Staff Report

To: Salt Lake City Planning Commission
From: Kelsey Lindquist, (801) 535-7930
Date: February 8, 2017
Re: PLNSUB2016-00914 & PLNSUB2017-0040

Planned Development and Minor Subdivision Plat

PROPERTY ADDRESS: 1008 South 1100 East
PARCEL ID: 16-08-406-014-0000 and 16-08-406-037-0000
MASTER PLAN: Central Community Master Plan
ZONING DISTRICT: R-1/5000 Single-Family Residential

8. Issue 8. Buffering Abutting Properties – Resolved with Conditions

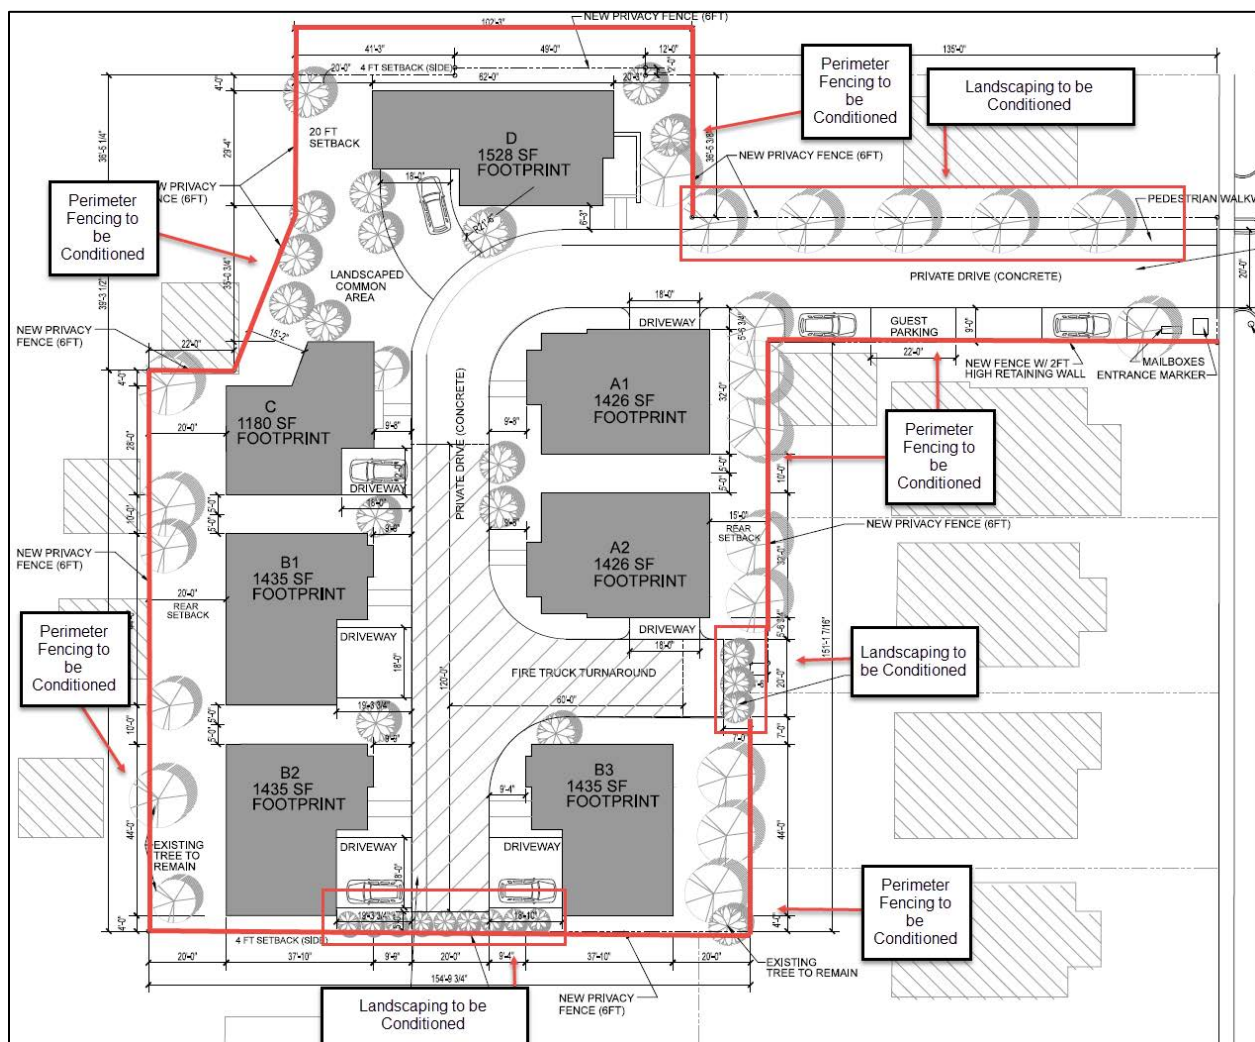
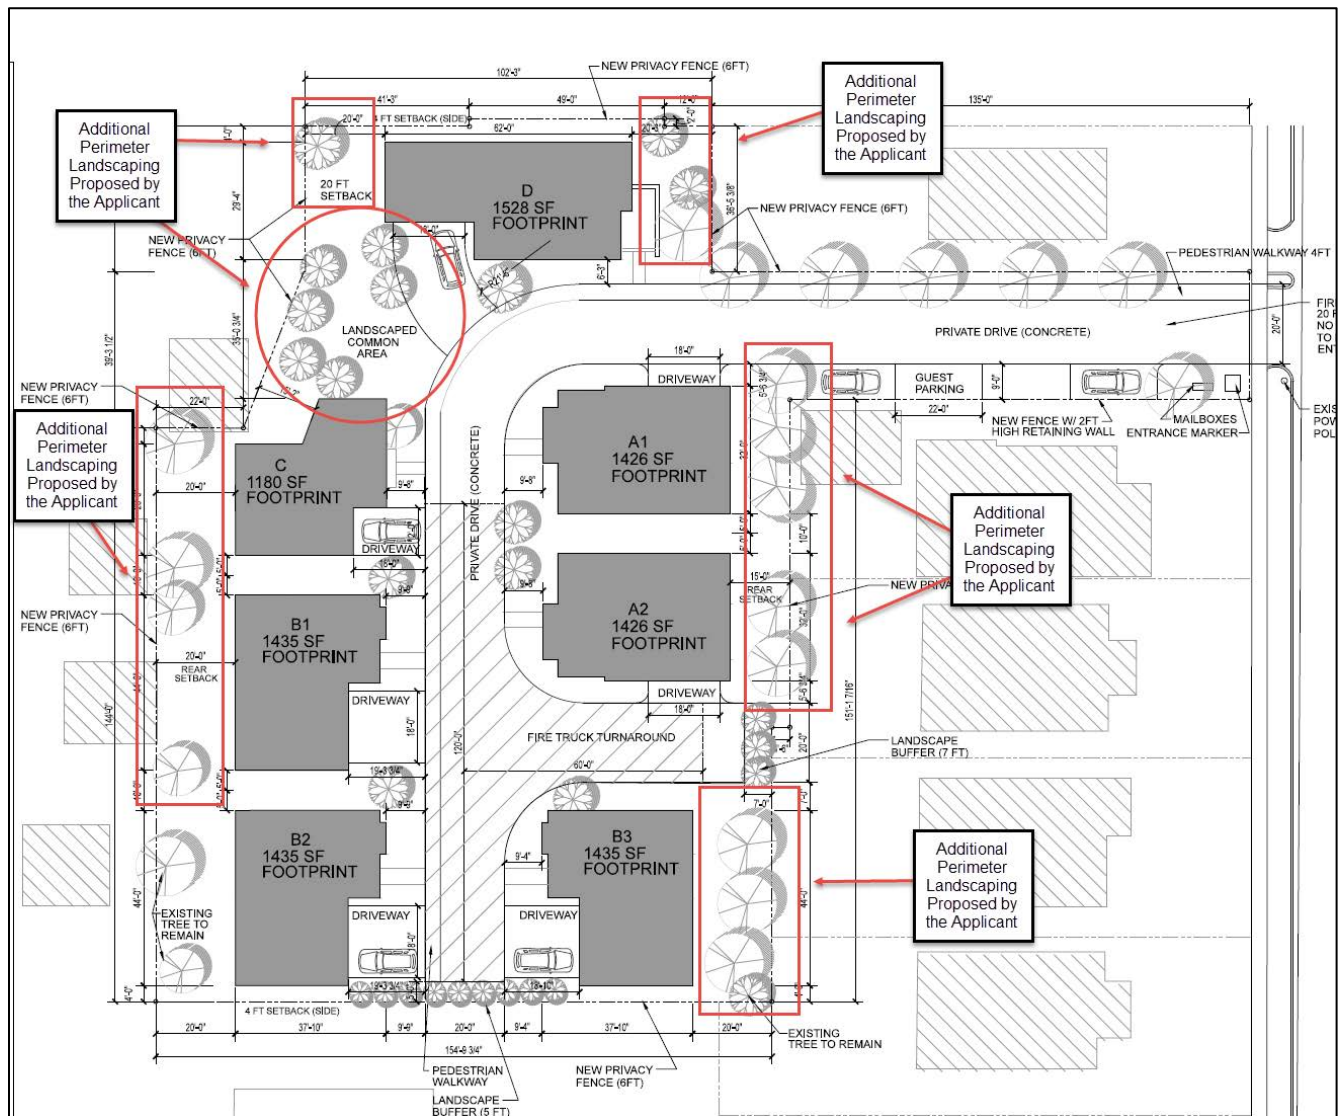
The initial proposal had reduced rear yards for each structure with very little buffering provided. After comments were received from the community, the applicant submitted updated proposals, which included larger rear yards and a landscaping proposal. The applicant is proposing to preserve three existing trees that are not within the buildable area. In addition to preserving the existing mature trees, the applicant is proposing to add additional landscaping to screen the private drive. These areas include the eastern, southern and northern entry edge of the private drive. Per 21A.48, the proposal does not need to include a landscape buffer for the private drive. These specific areas of the proposed landscaping should be conditioned as part of the approval to ensure that the applicant provides screening and buffering for the abutting properties. Additionally, the proposed perimeter fencing should also be a condition of approval to ensure that the development is providing a visual screen, which is discussed above in issue 6. The areas highlighted in the image below, illustrate the areas that should be required as a condition of approval.

In addition to the conditioned landscaping, the applicant is also proposing additional vegetation along the periphery of the development. The illustration below, highlights the additional areas of landscaping that are not a condition of approval. The applicant is proposing these

additional areas to further aid the mitigation of potential impacts to the abutting properties, as well as the properties within the development. Through providing the full rear yard setback requirement, proposing lower heights and providing adequate landscaping, the full perimeter of the planned development is buffering the neighboring properties. Please reference Attachment D, for the full details of the landscaping proposal.

Condition: The proposed landscape buffer for the private drive and the perimeter fencing required as a condition of approval.

9. *Issue 9. Additional quest parking for the overall development – Resolved with Conditions*

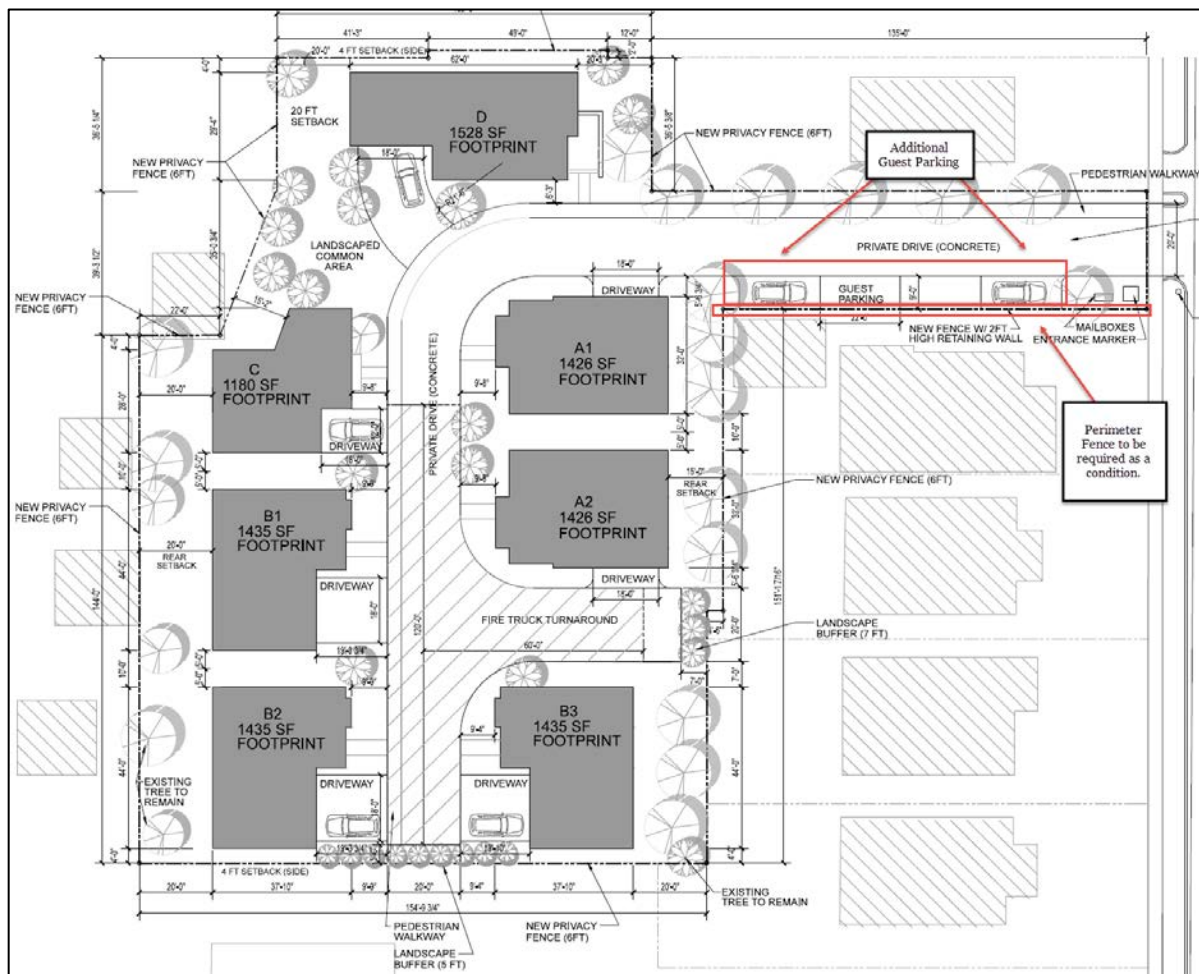
Concerns regarding parking impacts were raised from the neighborhood. The existing multi-unit structures provide adequate parking within the boundaries of the lot, with very little impact on 1100 East. The proposal includes an attached two-car garage for each structure, except for Lot 2 (Structure C) which will have a single-car garage and a tandem parking space. Chapter 21A.44.030 specifies that each single-family structure will provide two off street parking spaces.

In addition to the concerns raised about parking impacts, there have been additional concerns regarding too much parking and the potential impact on air quality for the abutting neighbors. To aid in mitigating the impact of the proposed additional guest parking spaces, the applicant is proposing to install a fence. The fence **will be located on top of a proposed two foot (2') retaining wall**. The combination of the fence and the low retaining wall will help to shield some of the visual and noise impacts from the guest parking.
